September 30, 2022

Re: Goose Haven # 2 Expansion Substitute Water Supply Plan (WDID 0602537)
Goose Haven # 2 Expansion Pit, DRMS Permit No. M-2010-071 (WDID 0603019)
Sections 15, 21, 22, T1N, R69W, 6th P.M.
Water Division 1, Water District 6, Boulder County
SWSP ID: 5385

Approval Period: May 25, 2021 through December 31, 2022
Contact information for Mr. Wayland: 303-443-9521, pwayland@weilandinc.com

FIGURE 2
SITE PLAN SHEET-1

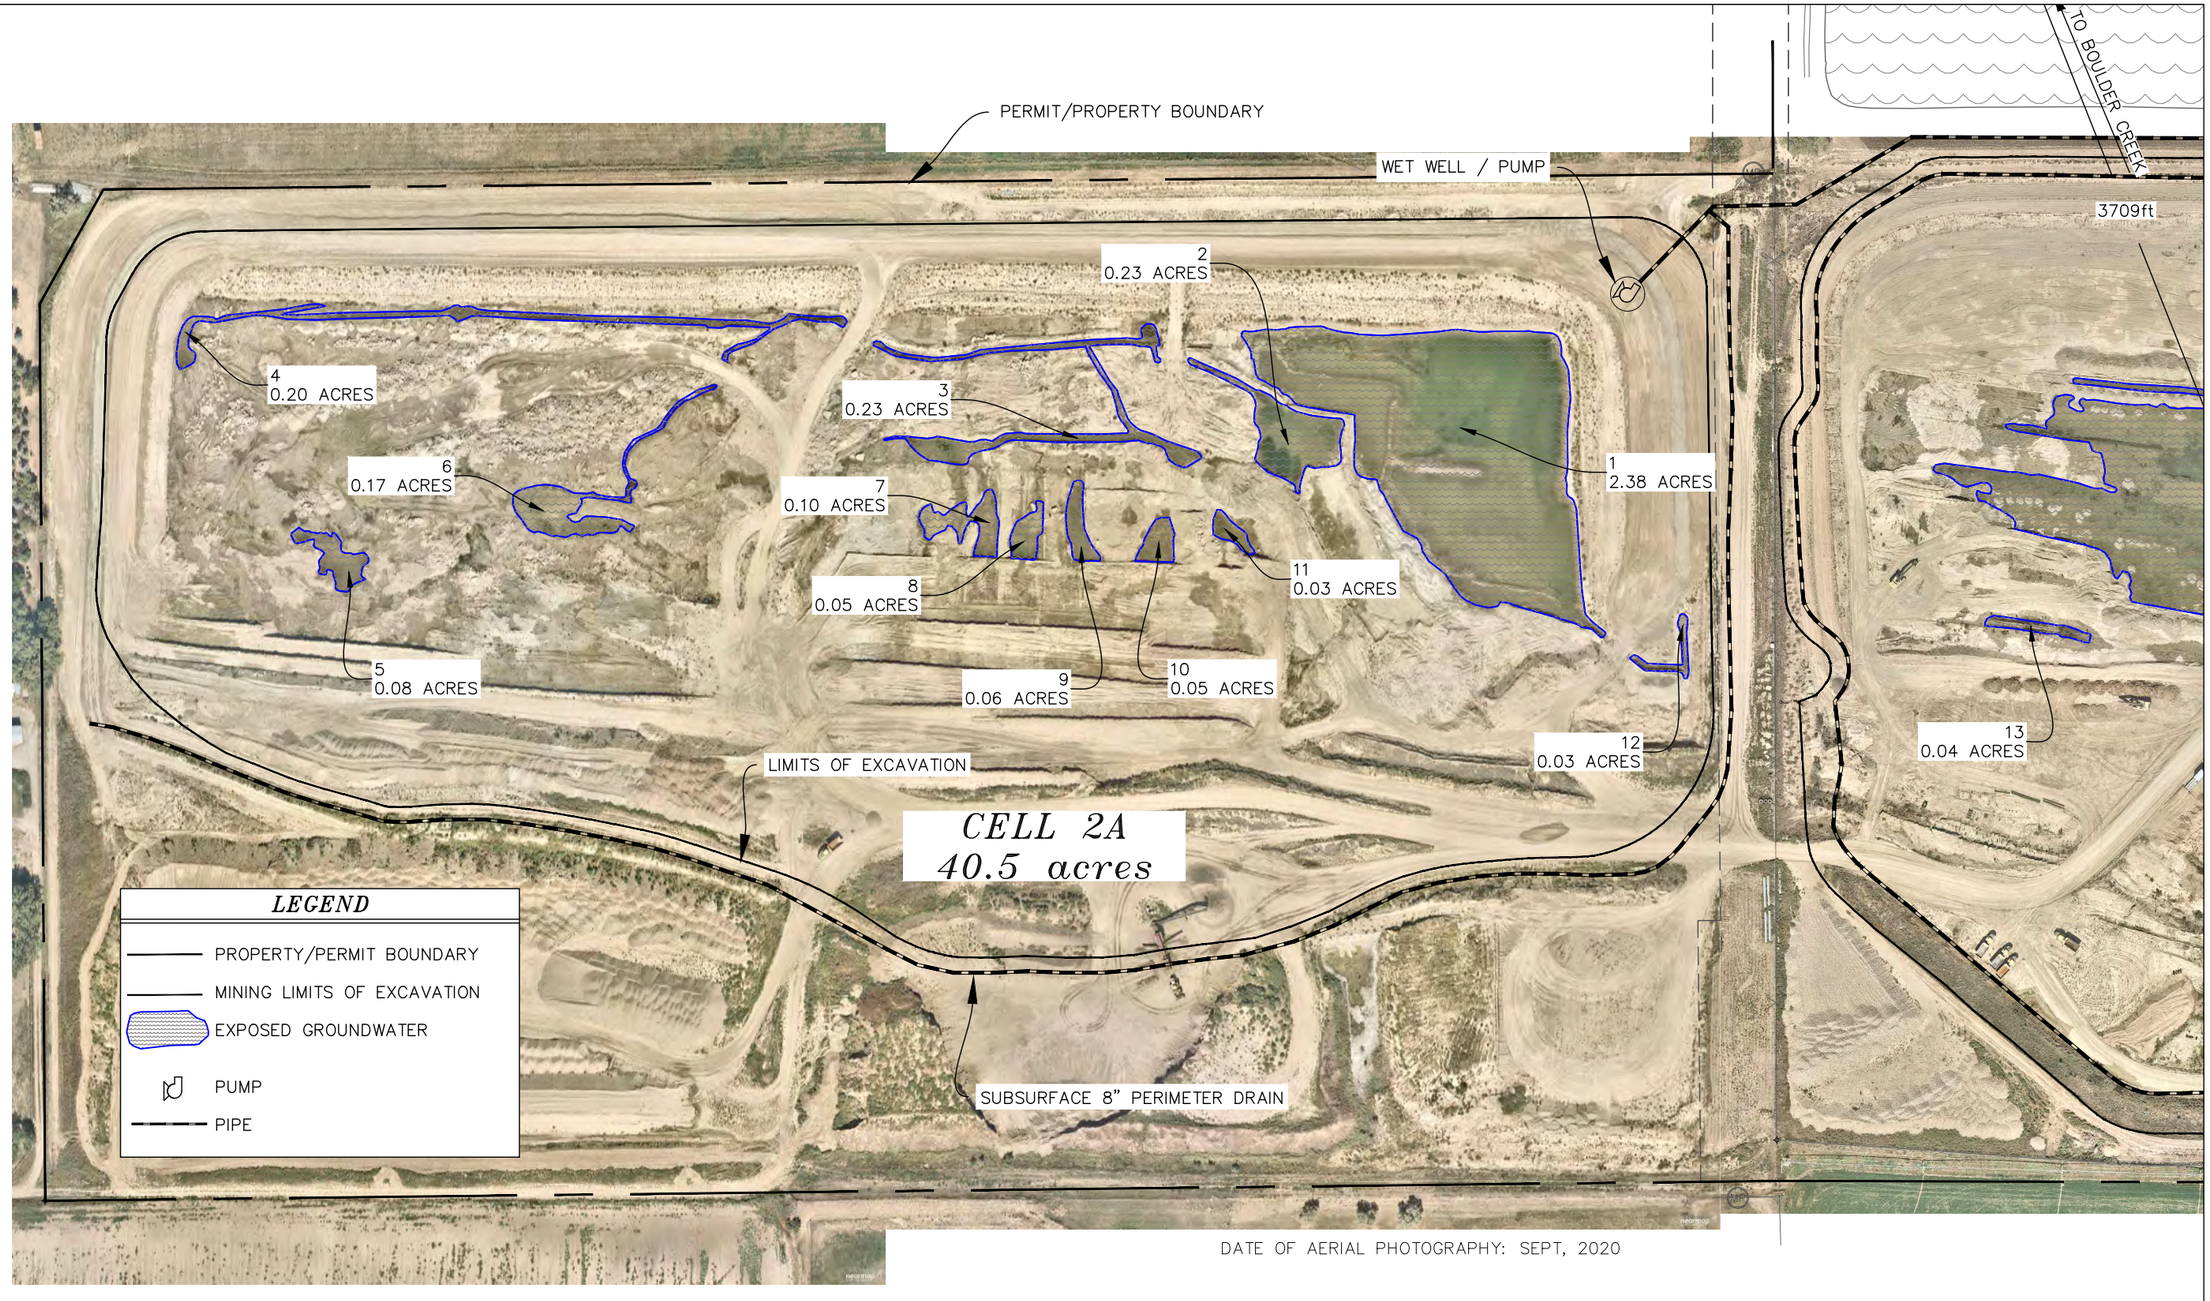
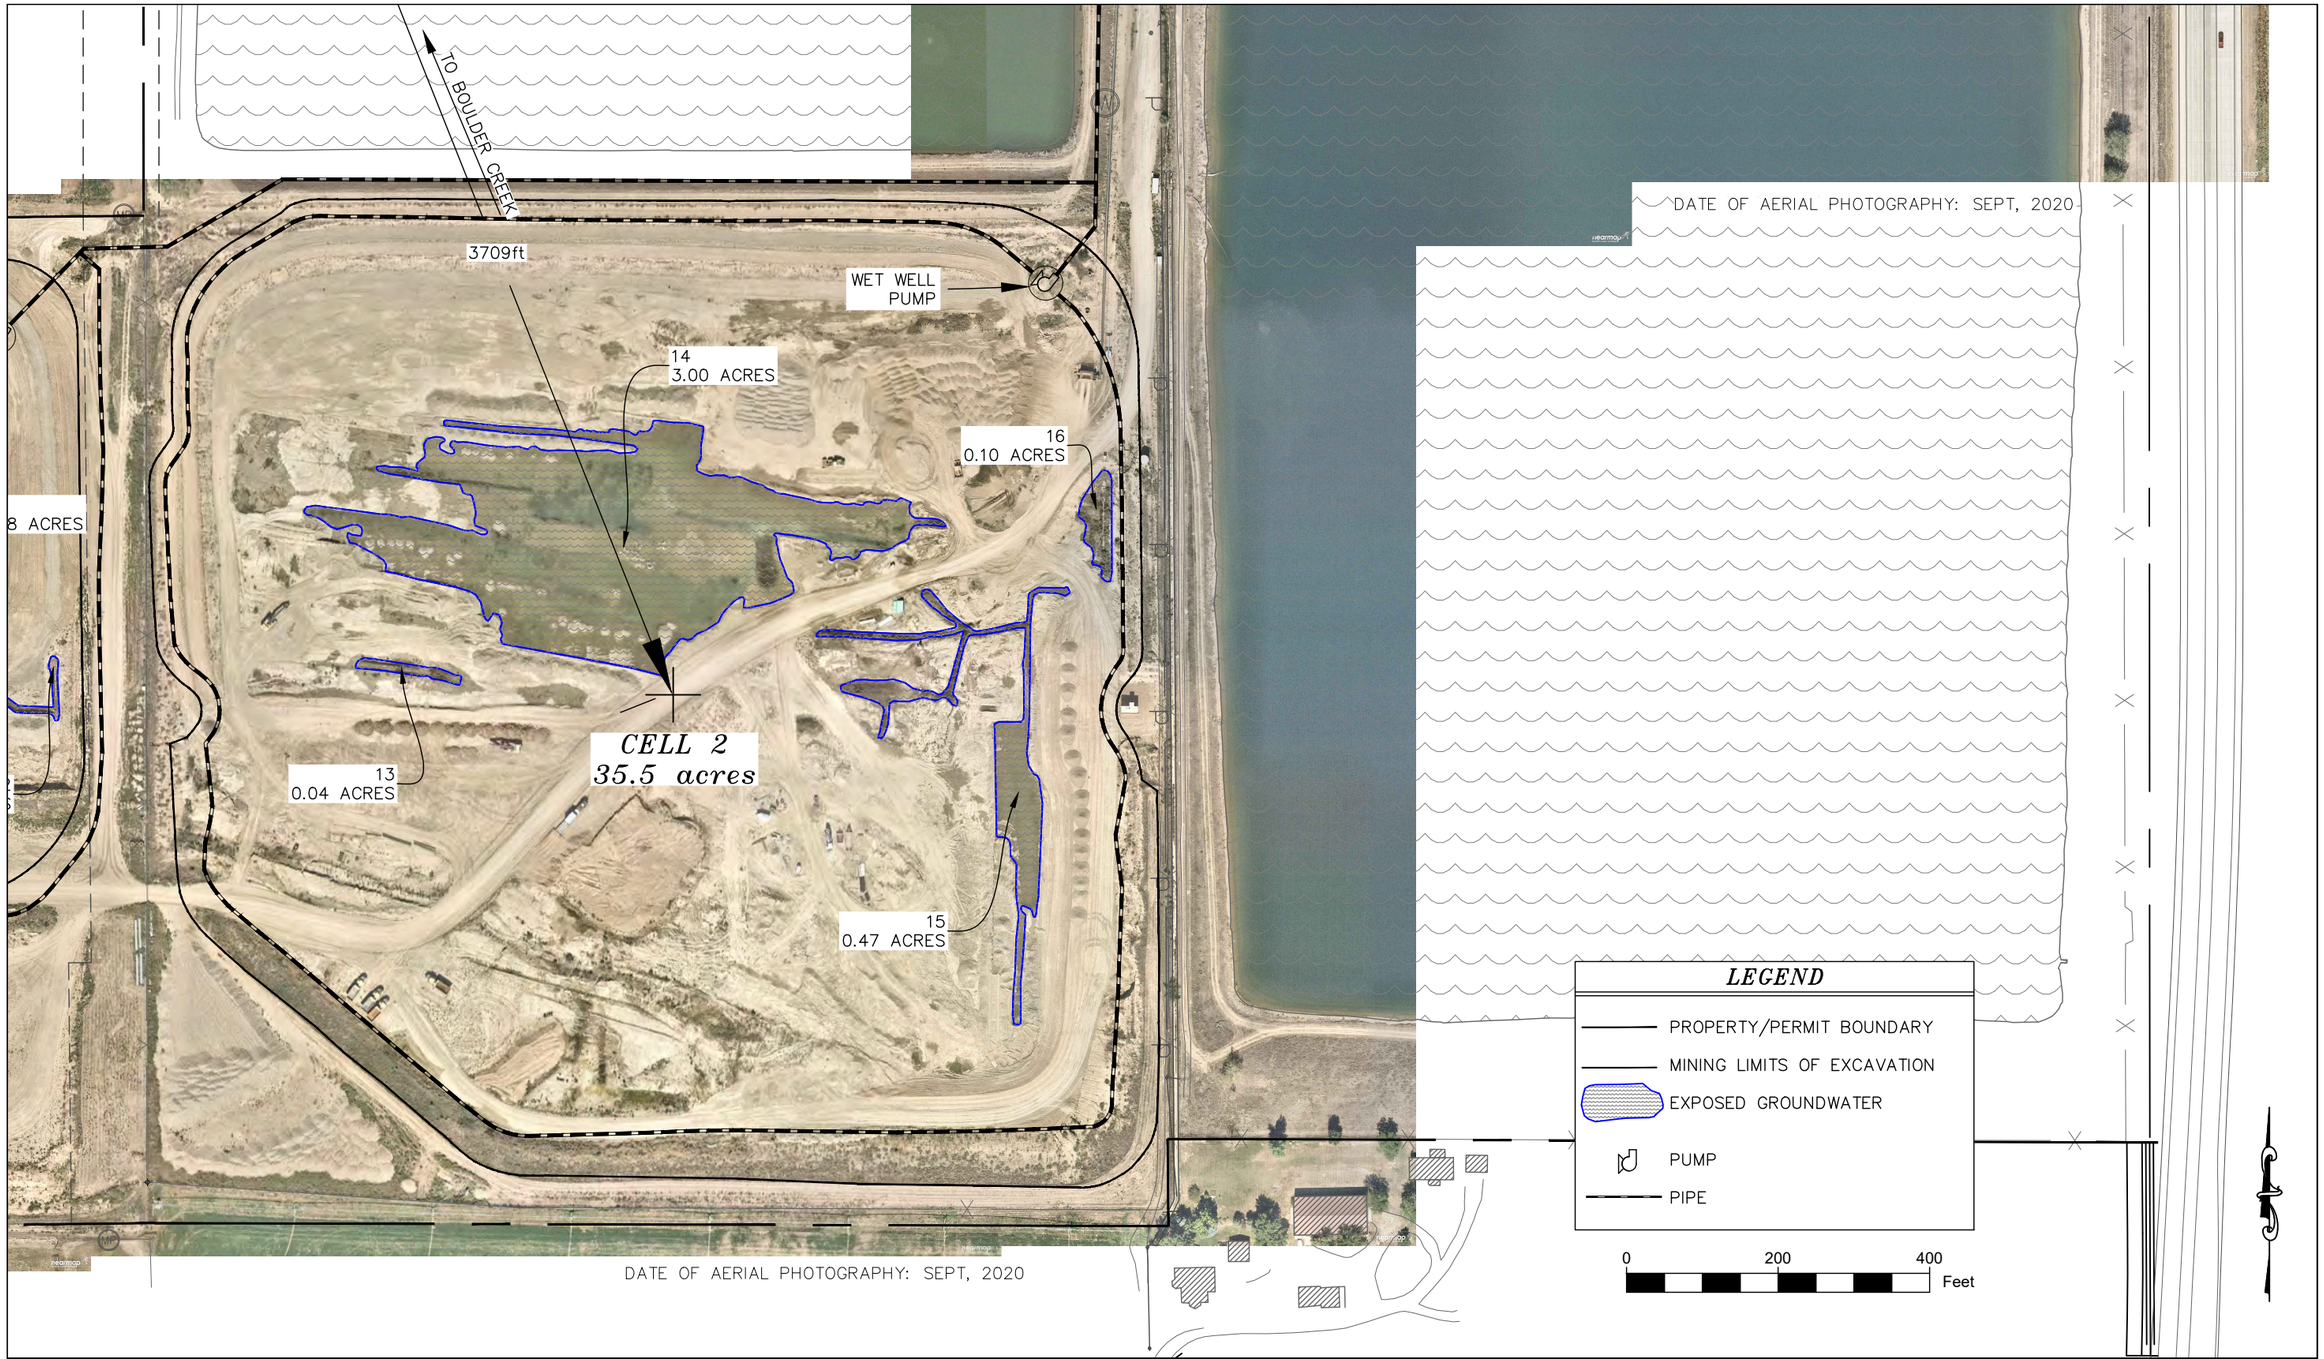
Currently, approximately 3.61 acres are exposed in Cell 2A (shown on attached Figure 2 as areas 1-12), and 3.61 acres are exposed in Cell 2 (shown on attached Figure 2 as areas 13-16). In addition, 2.24 acres are exposed in Cell 4 (shown on attached Figure 2 as areas 17-23). The net evaporation from the estimated exposed water surface is 9.07 acre-feet for Cell 2, 9.07 acre-feet for Cell 2A, and 5.63 acre-feet for Cell 4, for 2021 and 2022, as shown in Table AI.1, column 7.

3. The total surface area of the groundwater exposed at the site during the period of this SWSP must not exceed 3.61 acres in Cell 2A, 3.61 acres in Cell 2, and 2.24 acres in Cell 4, resulting in evaporative loss of 9.07 acre-feet for Cell 2A, 9.07 acre-feet for Cell 2, and 5.63 acre-feet for Cell 4.
